# City of Charlottesville BPAC/Tree Commission Joint Meeting

September 27, 2018

# Tree Commission Comments

SECTION C - 9TH ST. BETWEEN MARKET ST. AND E. JEFFERSON ST.

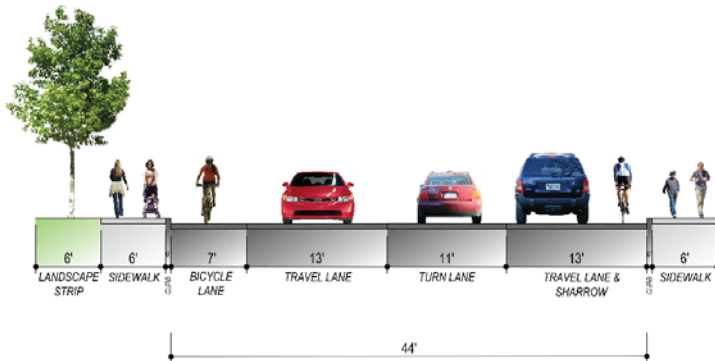
- The consensus of the Steering Committee at its June 28 meeting was that the redesign of the 9th St. NE segment of the project (section C) offered an excellent opportunity for pedestrians, bicyclists, and motorists all to enjoy this stretch of a major gateway to our downtown. It is important to note that 9th St. NE is ranked second (out of 105) as a 'Priority Corridor' in the Streets That Work Design Guidelines. (See Appendix D. Streets That Work Priority Locations, p. A-30.) The Commission recognizes the constraints in accommodating all of these uses, but the reality is that green space and shade are essential for enjoyable use by all. The current 4' planting strip ensures that only small canopy trees will thrive and that large canopy trees, while possibly surviving, will more likely fail over time than if they had been planted with sufficient soil volume. For this reason, the Commission advocates for the widest planting strip possible to accommodate large canopy trees. The Commission strongly recommends that the strip be expanded to 5' on either side by reducing the bike lane buffer by 1'.

- Buffers should be at least 18 inches wide because it is impractical to mark a zone narrower than that.

- Buffers provide greater shy distance between motor vehicles and bicyclists
- Buffers provide space for bicyclists to pass another bicyclist without encroaching into the adjacent motor vehicle travel lane
- Buffers provide a greater space for bicycling without making the bike lane appear so wide that it might be mistaken for a travel lane or a parking lane
- “nearly nine in 10 cyclists preferred a buffered bike lane to a standard lane. Seven in 10 cyclists indicated they would go out of their way to ride on a buffered bike lane over a standard bike lane, ....

- Current streets that work requirements for curbside buffer zone is 4' Minimum and 6' Desired.

- It is likely one side of 9th Street/E. High Street will have some or all overhead wires limiting tree selection to medium size trees
- Given the on-going adjacent developments, redevelopment in the near or long term is likely. Areas behind the curb may not be constructed for the long term
- Soil volumes with the longer linear planting strip may support a few larger trees. Details to be finalized in final design
- Note 9<sup>th</sup> Street/E. High Street is rich with underground utilities that may limit or change plantings

SECTION D - EAST HIGH ST. BETWEEN 9 1/2 ST. AND CFA

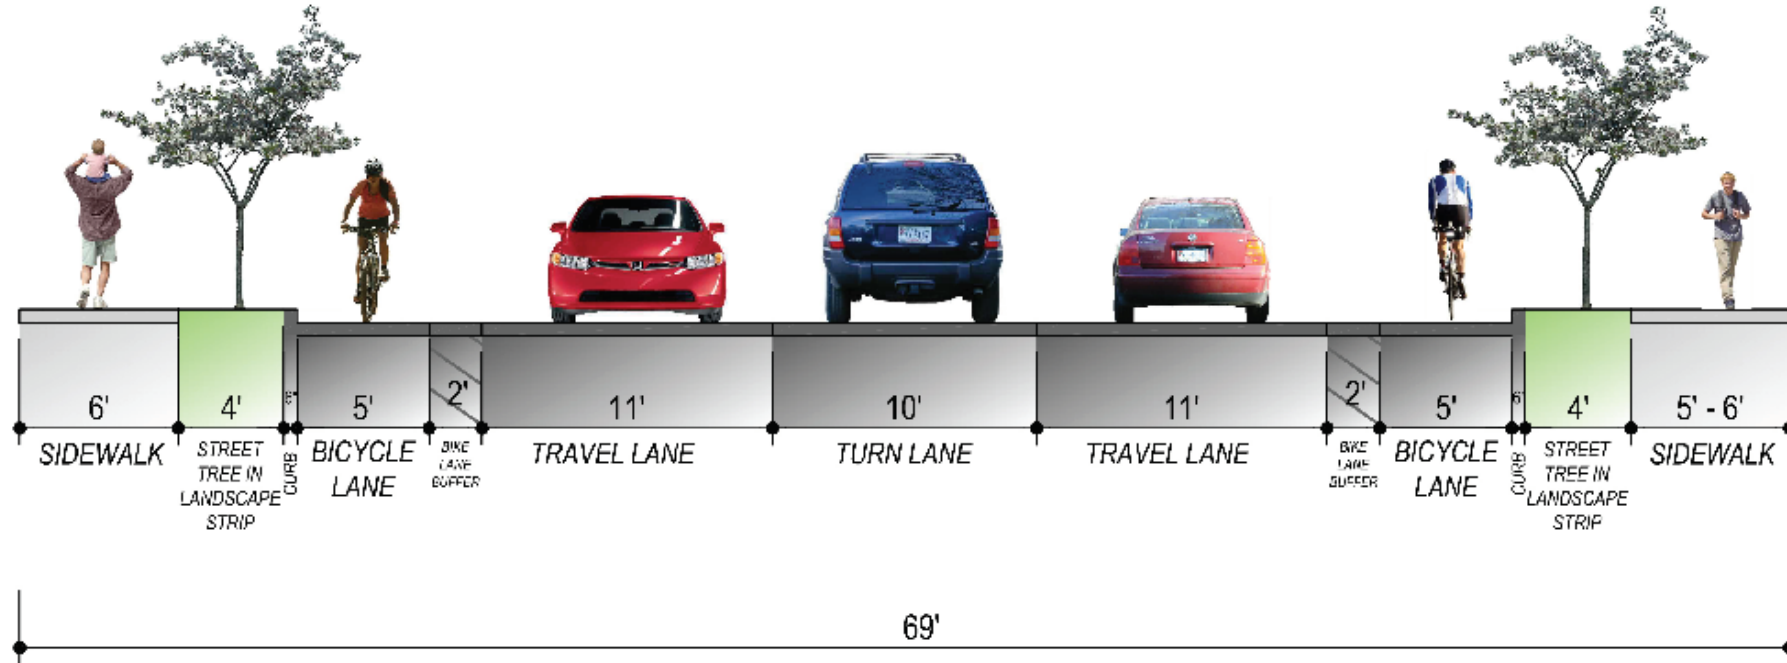
**Q.** Is the striped median in Section (D) required for fire trucks?

**Q.** The absence of a planting strip between the sidewalk and road on one or both sides of the East High to Locust segment of the project (section D) along with the complete elimination of a planted median does not reflect the community's clearly stated desire. It also fails to achieve the project goal of enhancing a gateway street.

- *Fire apparatus access roads shall have an unobstructed width of not less than 20 feet, exclusive of shoulders.....*

2012 VA Fire Prevention Code, Section 503.2.

Shifting the alignment to the south, east of Lexington will allow for a planting space along the North side of the road
